TRANS/WP.29/GRE/2004/5  
16 January 2004

DRAFT PROPOSAL FOR AMENDMENTS TO REGULATION No. 87

(Daytime running lights)

Transmitted by the expert from the Working Party "Brussels 1952" (GTB)

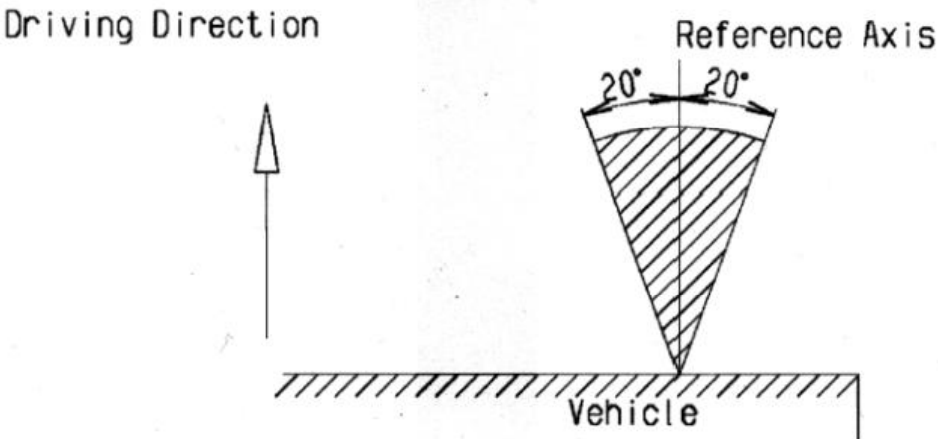
"7.1. The luminous intensity of the light emitted by each lamp shall not be less than 500 cd in the axis of reference.

7.2. Outside the reference axis and within the angular fields defined in the arrangement diagram in annex 7 to this regulation, the intensity of the light emitted by each lamp must:

7.2.1. In each direction corresponding to the points in the table of standard light distribution reproduced in annex [3] to this Regulation, be not less than the minimum specified in paragraph 7.1. above, multiplied by the percentage specified in the said table of the direction in question, and

7.2.2. not exceed 1500 cd in any direction the lamp is visible

7.3.1. throughout the field defined in the diagram in annex 7, the intensity of the light emitted must not be less than 1.0cd.

7.3.2. [As an alternative, at the discretion of the manufacturer, a minimum area of 12.5 cm<sup>2</sup> must be visible when measured from H-20° outboard to H-20° inboard, of the reference axis.]"

"8. ILLUMINATING SURFACE

The area of the illuminating surface shall be not less than 25 cm<sup>2</sup> and not more than 200 cm<sup>2</sup>."
